Licence Number L8934/2015/1

Licensee Big Bell Gold Operations Pty Ltd

Premises Central Murchison Gold Project – Big Bell
Mining Tenements M20/17, M20/99, M20/192, L20/21,
L20/40, G20/2, G20/3, L20/39, L20/41, M20/252,
M20/307, M20/333, M20/418, M20/435 and G20/1
As depicted in Schedule 1

Amendment

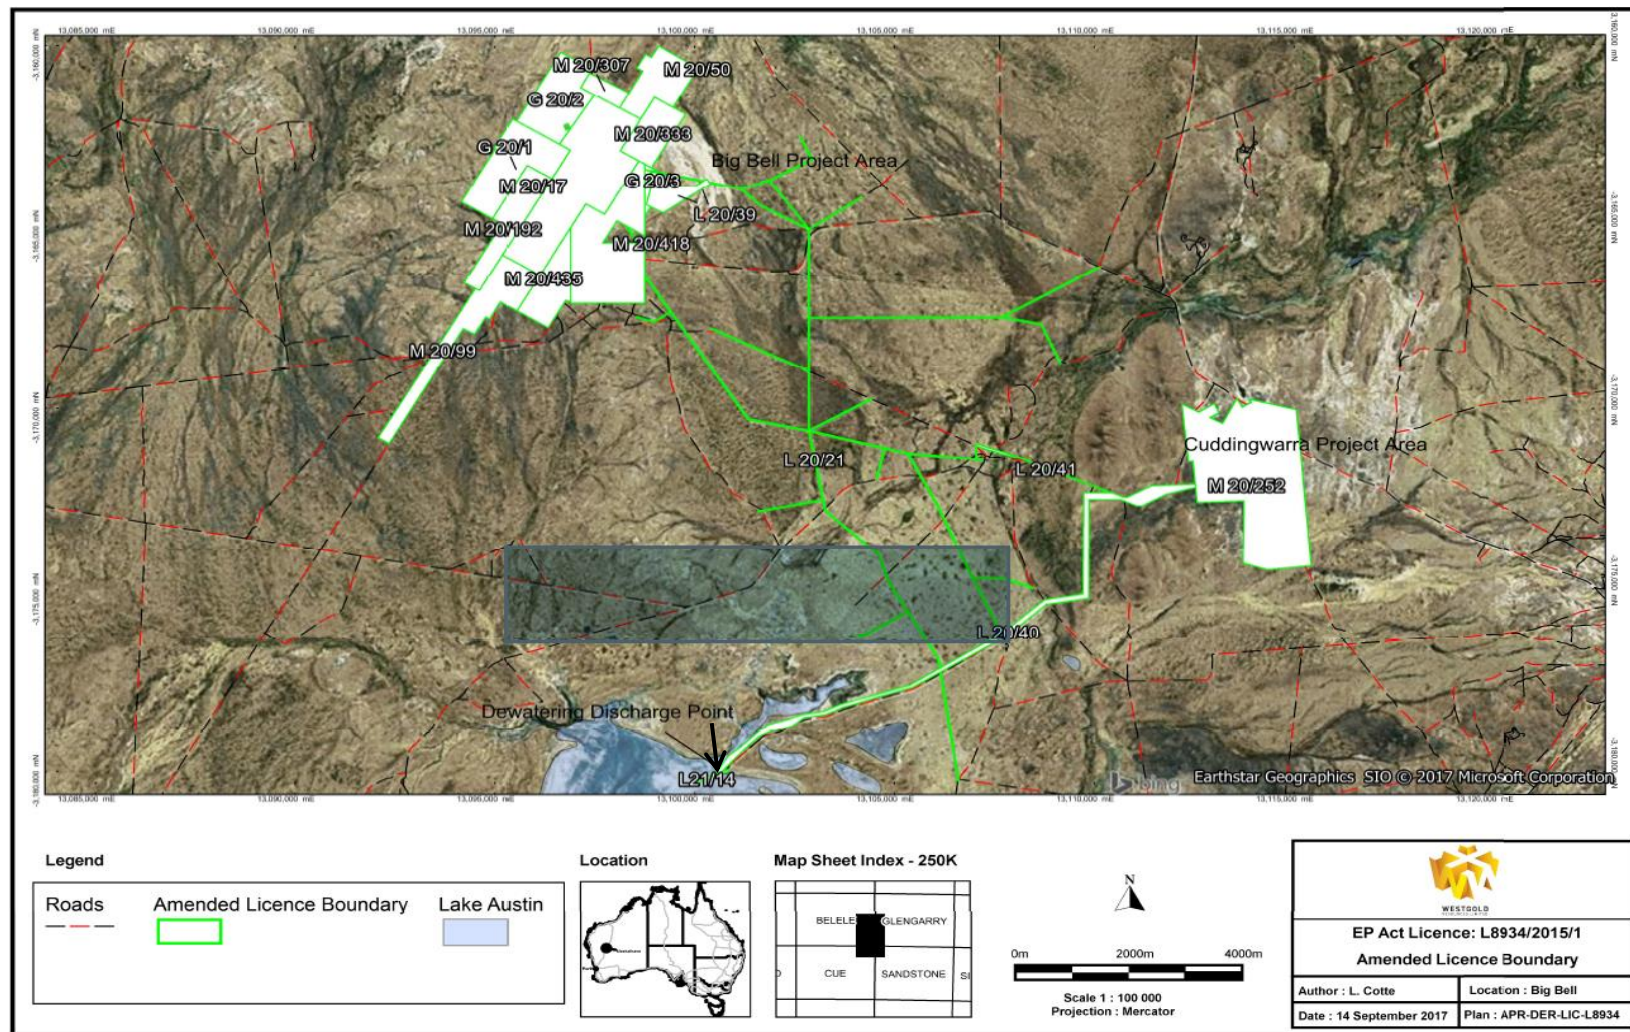
10. The Licence is amended by replacing the existing Premises Map in Schedule 1 with the figure below and by deleting the text shown in strikethrough and replacing with the text shown in underline and bold below:

~~The Premises is shown in the map below. The red line depicts the premises boundary. The location of the emission point and monitoring location defined in Tables 2.2.1 and 2.3.1 are shown in the map below.~~

The Premises is shown in the map below: L8934/2015/1 Amended Licence boundary. The green line shows the mining tenements of the Premises and is the Premises boundary. The dewatering discharge point is also shown on the map.

Map of Lake Austin aquatic assessment monitoring points.

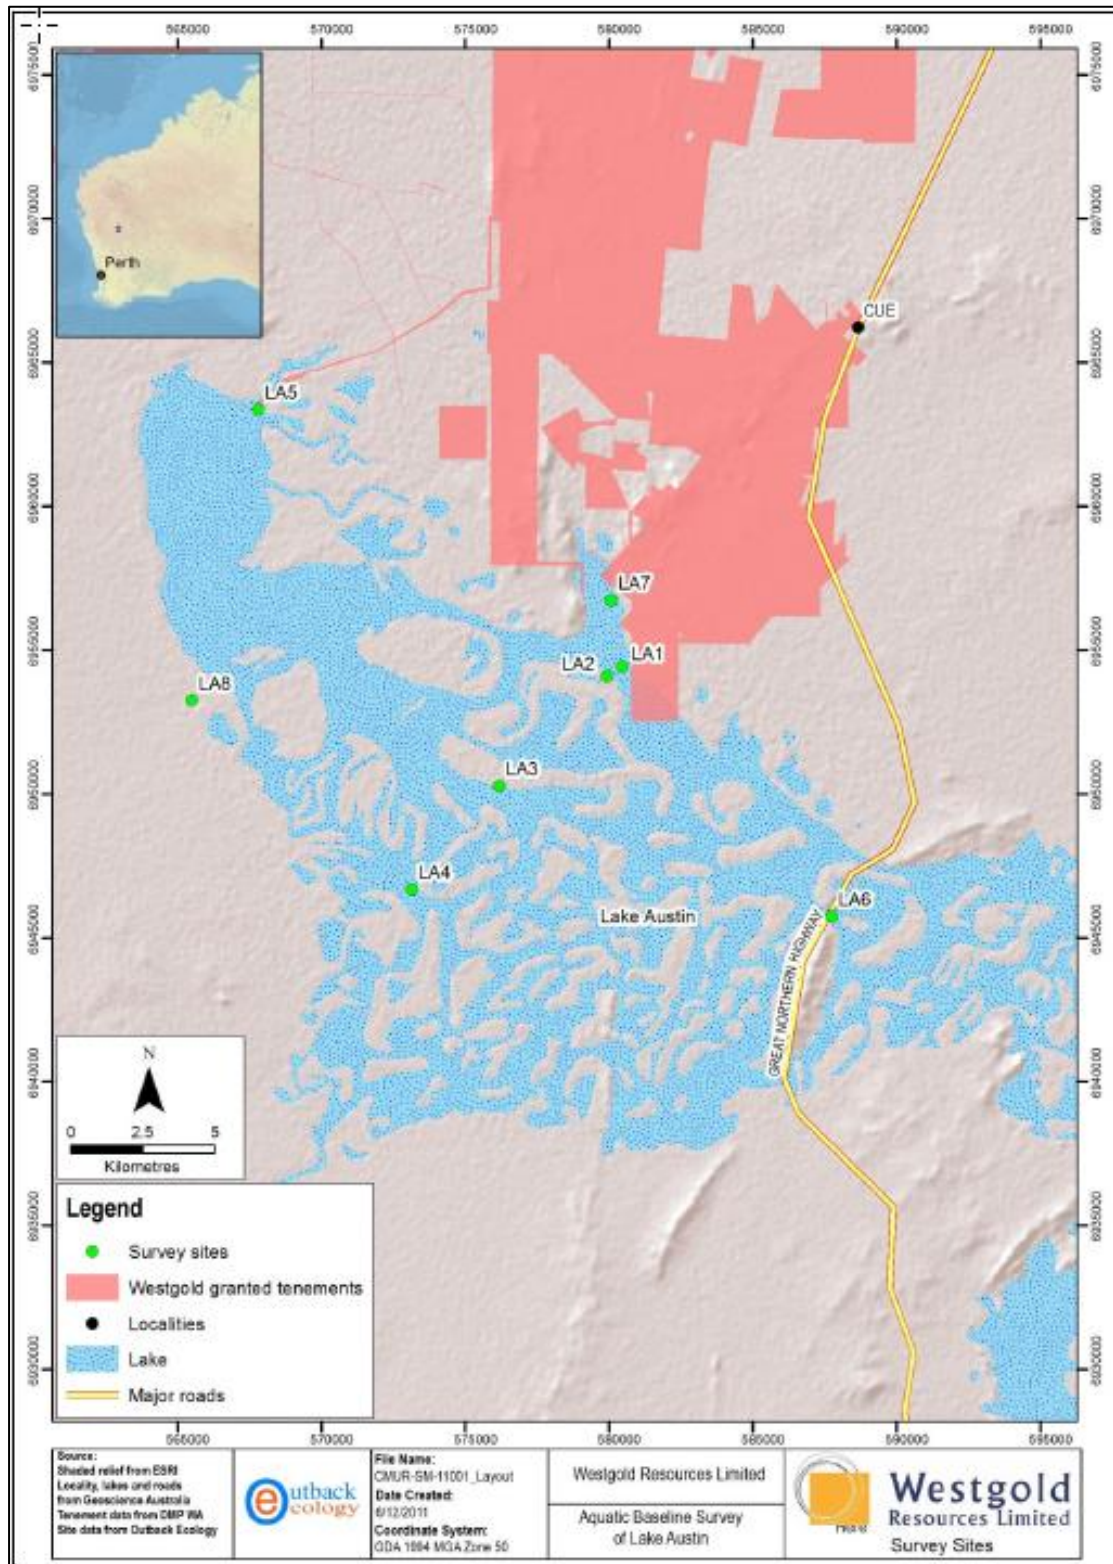
11. Schedule 1 Maps is amended by adding in the text and figure below.

The locations of the aquatic assessment monitoring points (LA1 to LA8) as defined in condition 3.5.1 is shown below.
